1. APPLICATION FOR DEMOLITION AND NEW CONSTRUCTION AT 270 BUCHAN ROAD, A PROPERTY DESIGNATED UNDER PART V OF THE *ONTARIO HERITAGE ACT* AND LOCATED IN THE ROCKCLIFFE PARK HERITAGE CONSERVATION DISTRICT

1. Manager's report, Right of Way, Heritage and Urban Design Services, Planning, Infrastructure and Economic Development Department dated 27 March 2017 (ACS2017-PIE-RHU-0004)

SUBJECT: Application for demolition and new construction at 270 Buchan Road, a property designated under Part V of the *Ontario Heritage Act* and located in the Rockcliffe Park Heritage Conservation District

Document 9 – Existing Site Plan

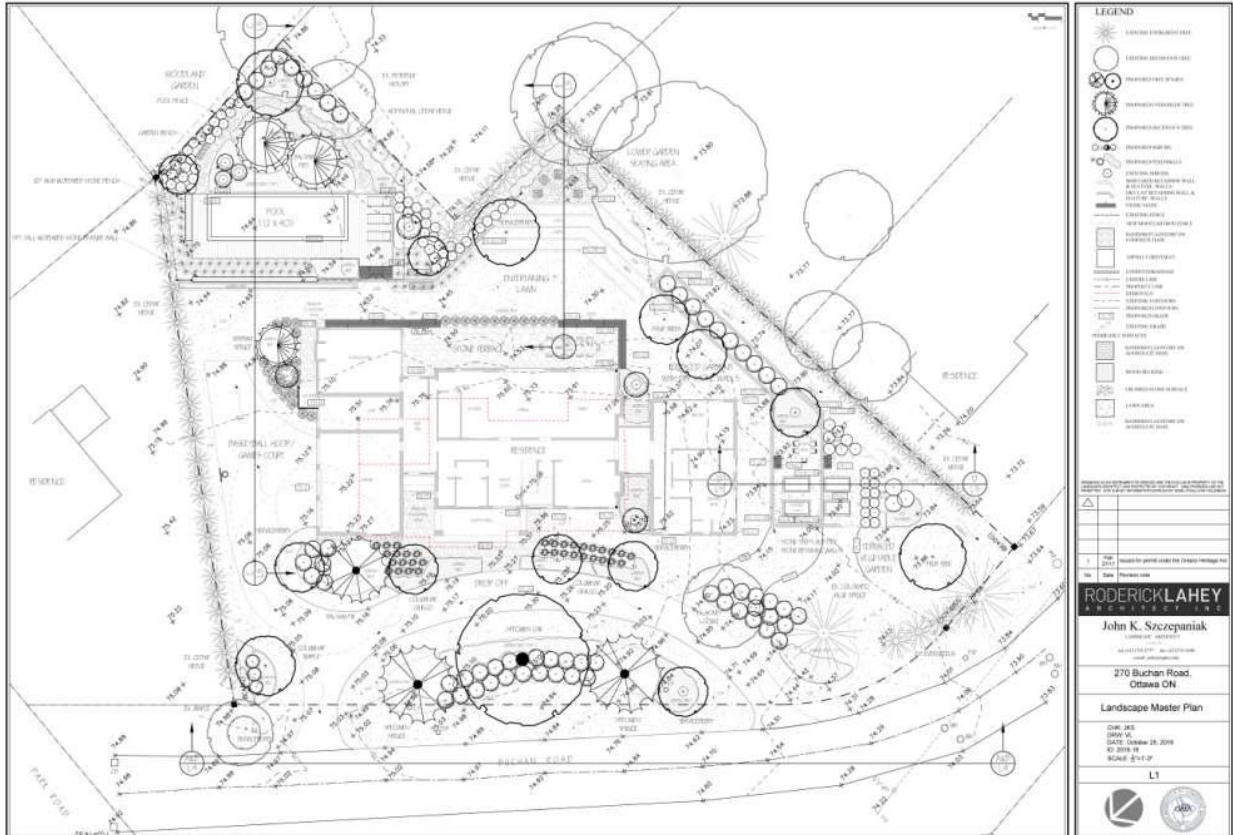
- The proposed landscape plan retains the distinctive cedar hedges that have traditionally defined the edges of the property and proposes the addition of mature trees, a woodland garden surrounding the proposed pool, a vegetable garden, and stone terraces and a lawn with grassed terraces. The area north of the garage towards the property line is extensively paved for basketball, and consideration should be given to restricting the paving to the minimum required for easy access and egress to the three car garage.

- Aerial photographs from the 1950s onward show large lawns defining the property. Consideration should be given to substituting lawns or soft landscaping for some of the designed surfaces, such as the seating area at the top of the sod steps.
